**WHEELING PLAN COMMISSION
THURSDAY, SEPTEMBER 13, 2018 6:30 P.M.**

**AGENDA FOR A REGULAR MEETING OF THE PLAN COMMISSION
Board Room - 2 Community Boulevard, Wheeling, Illinois**

RE: **Docket No. PC 18-15**
Pizza Roncadin
236 Egidi Drive
Minor Site Plan and Appearance Approval of a Nitrogen Tank

RE: **Docket No. 2018-23**
H2O Express Car Wash
966 S. Milwaukee Avenue
Special Use-Site Plan Approval of a Car Wash Facility

2 South -Front Elevation
SCALE: 3/16" = 1'-0"

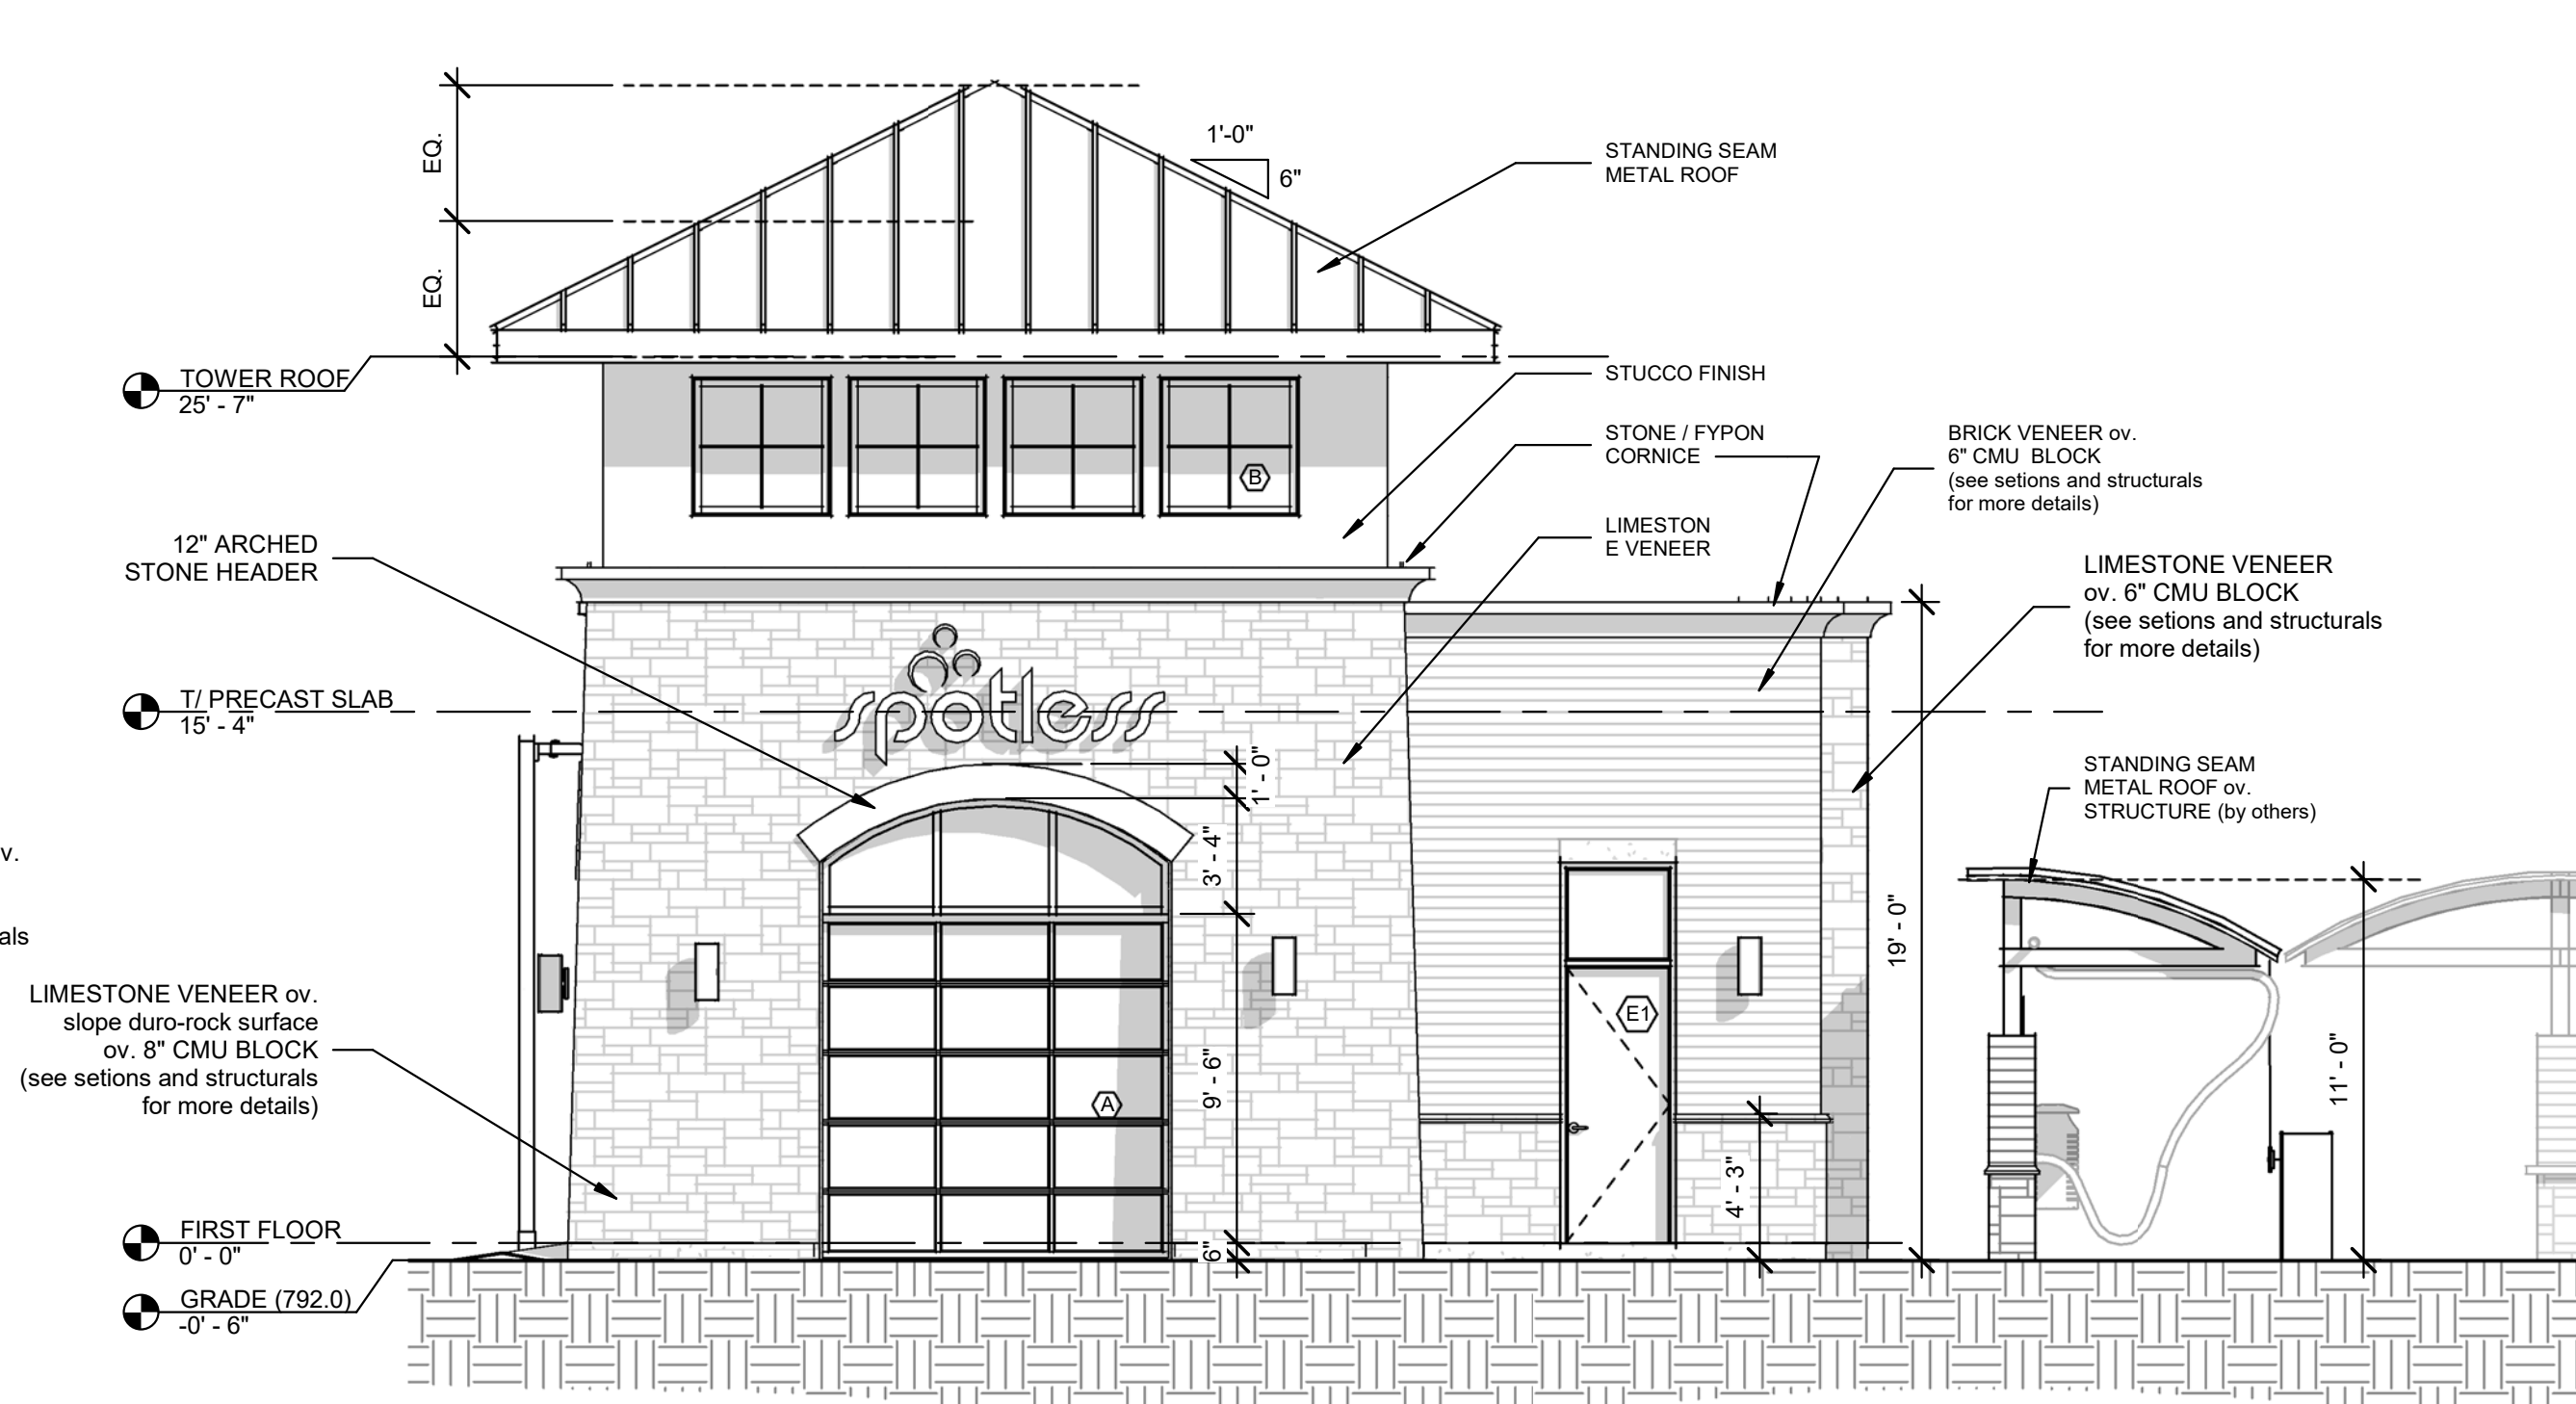
Elevation plans: Renderings and elevation plans are provided to describe the building exterior. It appears that the elevation labels are incorrect. The front elevation should be labeled east. The rear elevation should be labeled west. The main elevation should be labeled north and the side elevation should be labeled south. The front and rear elevations include tower elements with a metal standing seam hipped roof and clerestory windows below the roof line. Each lower wall of the tower elements are clad in limestone veneer. Overhead garage doors with a divided lite design and a 12 inch arched stone header are located on the east and west tower elevations. Fixed glass windows that are similar in design to the overhead garage doors appear on the south elevations of the towers. Between the east and west towers is a long stretch of flat roof with a decorative Fypon (synthetic stone) cornice. The majority of the north and south walls of this wash tunnel portion of the building is covered in brick. There is also four foot high raised foundation of limestone veneer. The same limestone veneer is carried vertical on pilasters that provide relief on each the north and south walls. A limestone trim separates the brick and limestone wall materials. Fixed windows are located throughout the north and south elevations. Limestone headers are shown above the windows. The Plan Commission may wish to inquire about the tint or opacity of the window glazing.

Trash Enclosure: A trash receptacle is situated at the northeast end of the parking aisle. Sheet A-3.2 provides elevation plans of the enclosure. It appears that the labels of these elevation plans are incorrect. The "west elevation" appears to actually be the south elevation, which includes the gates. The "south elevation" appears to actually be the east and west elevations with solid walls of brick veneer above a limestone veneer. The enclosure also has a limestone cap and limestone trim between the brick and limestone veneers. The appearance of the enclosure matches the building.

Signage: Multiple wall signs are shown on the elevation plans. Not enough detail is provided at this time to review or approve the signs. The sign plans shall be illustrative only.

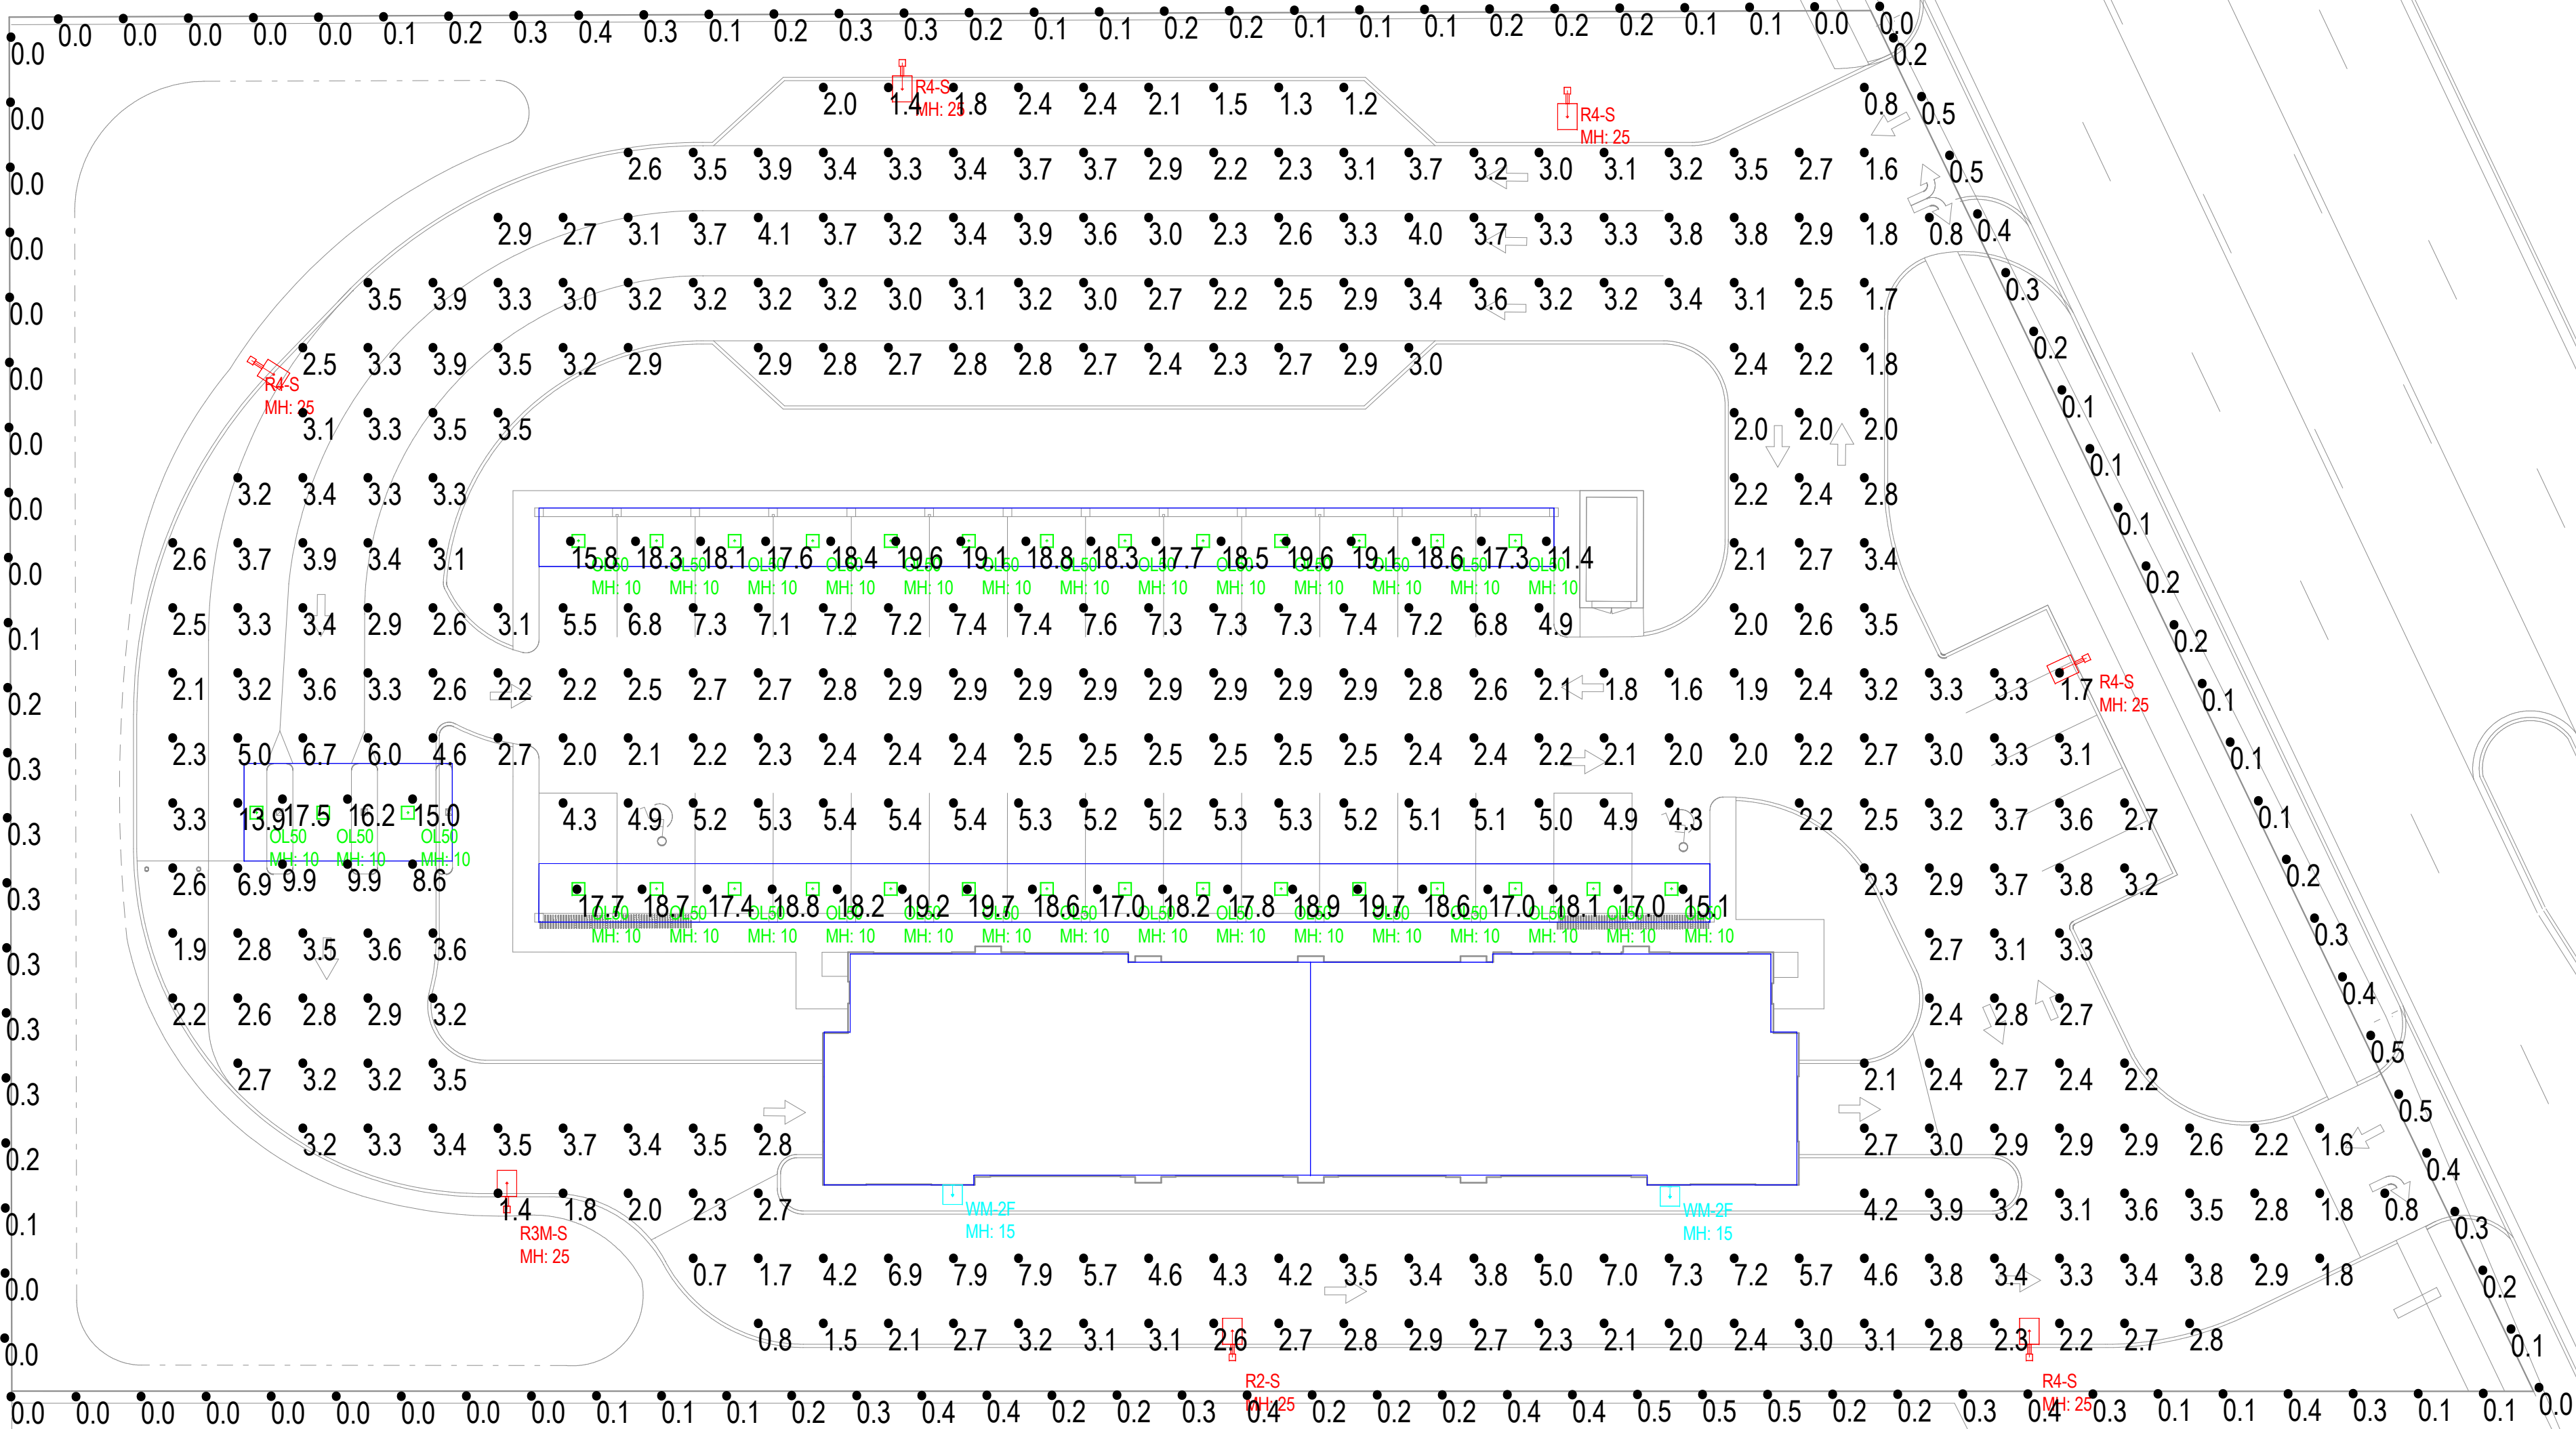
Site Lighting: The site lighting includes a mix of 25-foot high pole-mounted fixtures and canopy-mounted fixtures for the covered parking areas. The light locations are illustrated on the photometric plan. The Engineering Division noted a conflict with the location of a light pole and the water main. Minor modifications to the site lighting will be required at final engineering.
